UNITED STATES
NUCLEAR REGULATORY COMMISSION
WASHINGTON, D. C. 20555

SUBJECT: PRESSURE-TEMPERATURE OPERATING LIMIT CURVES, REQUEST NO. 89-08
(TAC NO. 75585) AND GENERIC LETTER 88-11 (TAC NO. 71509)

RE: LIMERICK GENERATING STATION, UNIT 1

AMENDMENT TO FACILITY OPERATING LICENSE

FIGURE 3.4.6.1-1

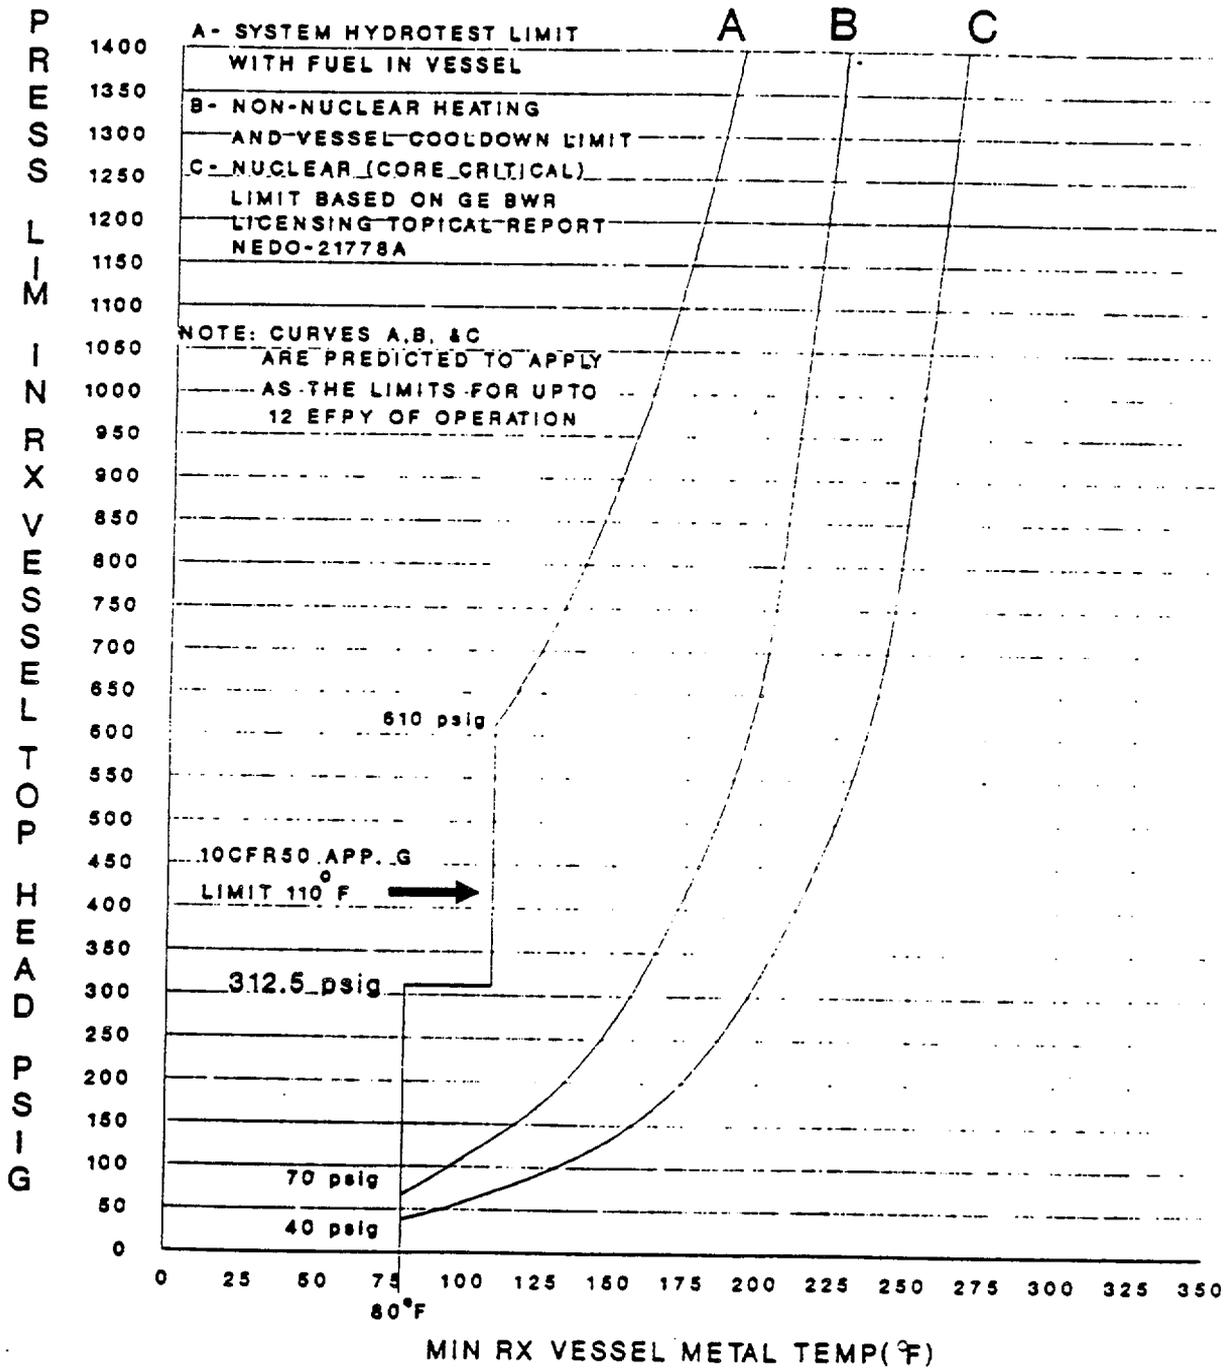
Specifically, the amendment would change the note on the Pressure-Temperature Operating Limit (PTOL) curve, figure 3.4.6.1-1, to reflect new, more conservative adjusted reference temperatures calculated in accordance with RG 1.99, Rev. 2. (These limits are subsequently referred to as P/T

limits.) The present note states that "curves A, B, and C are predicted to apply as the limits for 40 years (32 equivalent full power years, EFPY) of operation." The revised note for the same curves, (which are not being changed), states that "curves A, B, and C are predicted to apply as the limits for up to 12 EFPY of operation." Three curves in the same figure are also being deleted. These three curves are explicitly identified in the present TSs as not being limiting curves and have been "shown for information only." Sections 3.4.6.1 and 4.4.6.1 are being revised to remove the references to the A', B', and C' curves. The Bases section 3/4 4.6 and Bases Table B 3/4 4.6-1 are being revised to reflect the above changes. The proposed pressure-temperature (P/T) limits were developed based on RG 1.99, Rev. 2. The proposed revisions provide up-to-date P/T limits for the operation of the reactor coolant system during heatup, cooldown, criticality, and hydrotest.

The staff evaluated the effect of neutron irradiation embrittlement on each beltline material in the Limerick 1 reactor vessel. The amount of irradiation embrittlement was calculated in accordance with RG 1.99, Rev. 2. The staff has determined that the material with the highest ART at 12 EFPY was plate C7677-1 with 0.11% copper (Cu), 0.50% nickel (Ni), and an initial RT_{ndt} of 20°F.

For the limiting beltline material, plate C7677-1, the staff calculated the ART to be 60.4°F at 1/4T (T = reactor vessel beltline thickness) and 46.2°F for 3/4T at 12 EFPY. The staff used a neutron fluence of 4.5E17 n/cm² at 1/4T and 2.1E17 n/cm² at 3/4T. The ART was determined using Section 1 of RG 1.99, Rev. 2, because no surveillance capsules have been removed from the Limerick 1 reactor vessel.

The licensee used the method in RG 1.99, Rev. 2, to calculate an ART of 59.8°F at 12 EFPY at 1/4T for the same limiting plate material. The staff judges that a difference of 0.6°F between the licensee's ART of 59.8°F and the staff's ART of 60.4°F is acceptable. Substituting the ART of 60.4°F into equations in SRP 5.3.2, the staff verified that the proposed P/T limits for heatup, cooldown, and hydrotest meet the beltline material requirements in Appendix G of 10 CFR Part 50.

The staff concludes that the proposed P/T limits for the reactor coolant system for heatup, cooldown, leak test, and criticality are valid through 12 EFY because the limits conform to the requirements of Appendices G and H of 10 CFR Part 50. The licensee's submittal also satisfies Generic Letter 88-11 because the licensee used the method in RG 1.99, Rev. 2 to calculate the ART. Hence, the proposed P/T limits may be incorporated into the Limerick 1 Technical Specifications.
